RAI Volume 2, Chapter 2.1.1.4, Fifth Set, Number 1:

RAI Volume 2, Chapter 2.1.1.4, Fifth Set, Number 4:

RAI Volume 2, Chapter 2.1.1.4, Fifth Set, Number 6

RAI Volume 2, Chapter 2.1.1.4, Sixth Set, Number 1:

Figure 1. Fault Tree ESD20-SHIELD-TAD-TCAO1 with Ratio Equations

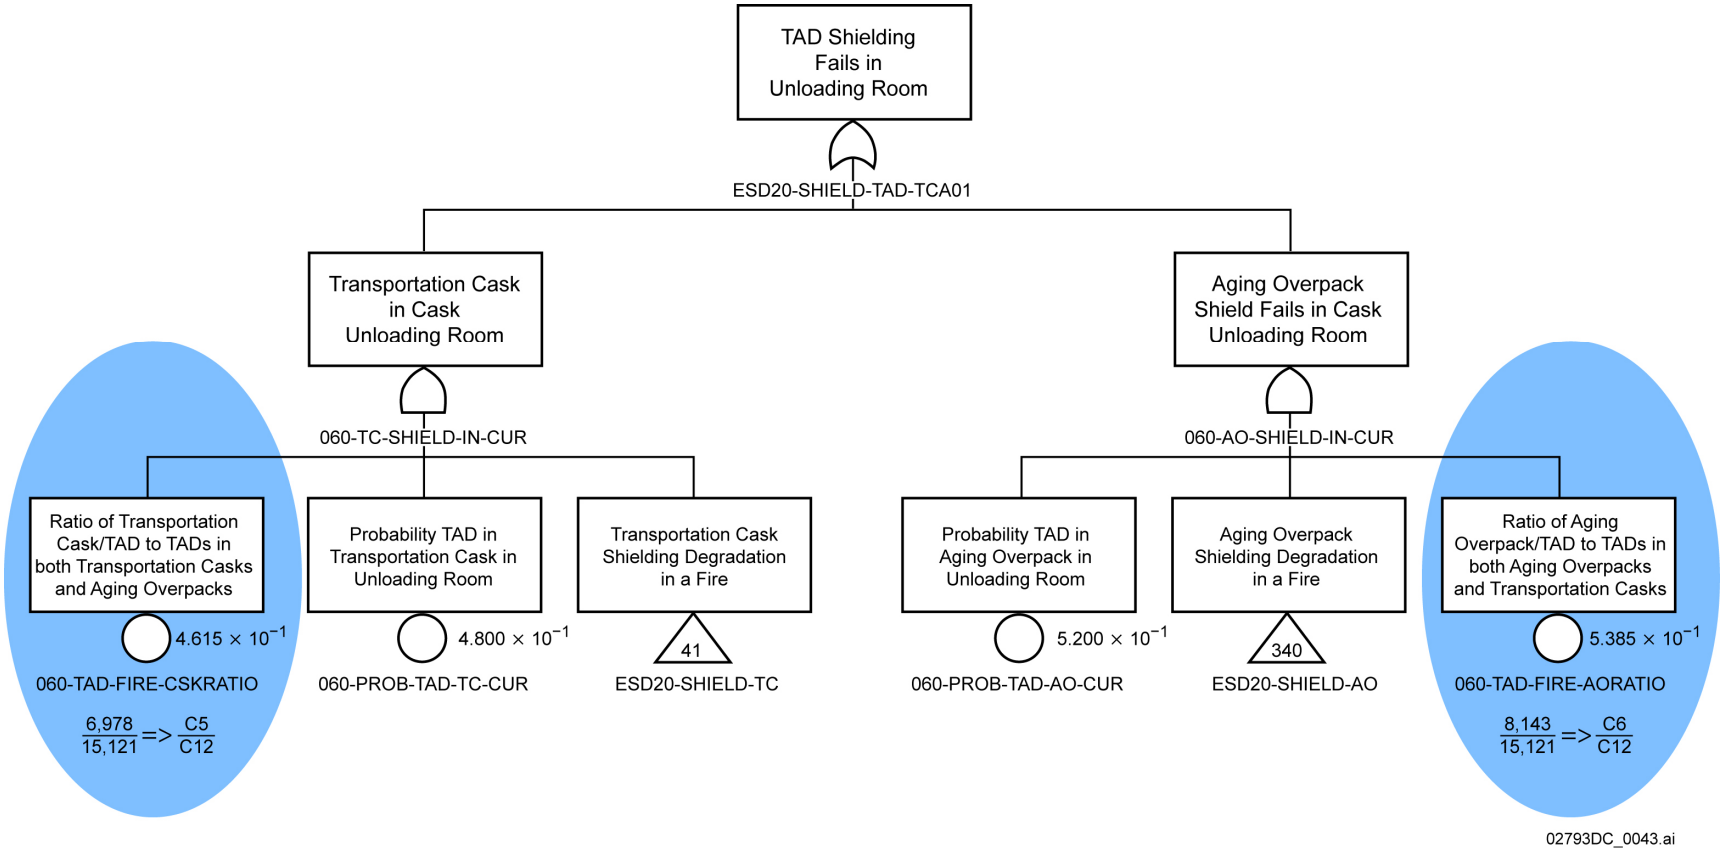
> For fire related event sequences, explain how the ratio of various waste form configurations to the overall number of a particular waste form were derived for the surface facilities (e.g., TAD in an Aging Overpack vs. Overall Number of TADs in Canister Receipt and Closure Facility).
>
> These ratios are used as basic event probabilities in event sequences. For example, the total number of TADs and individual TAD configurations in ESD20-SHIELD-TAD-TCAO1 are outlined in SAR Table 1.7-5; however, it is not clear how the ratios were derived for the event sequences.

Fault trees that support the fire event trees are developed for each waste form (e.g., per transportation, aging, and disposal (TAD) canister). Each waste form, however, is processed through the facilities with different overpacks, such as aging overpacks and transportation casks. As shown in Figure 1, the ratios allow the fault trees to be partitioned among these overpacks. As part of the event sequence quantification, the initiating event frequencies (developed using fault trees) are multiplied by the waste form throughput count being analyzed. For example, as shown in Figure 2 (see also BSC 2009, Figure A5-84), the event sequence quantification includes multiplication by a total number of TAD canisters processed in the Canister Receipt and Closure Facility (CRCF) over the preclosure period.

Table 2 provides a list of all fire related waste form throughput ratios, the fault trees which utilize them, and a description of the development of each ratio. In Figure 1, the fault tree identified in this RAI (ESD20-SHIELD-TAD-TCAO1) is annotated to illustrate the connection between the ratios in Table 2 and the fault tree basic events.
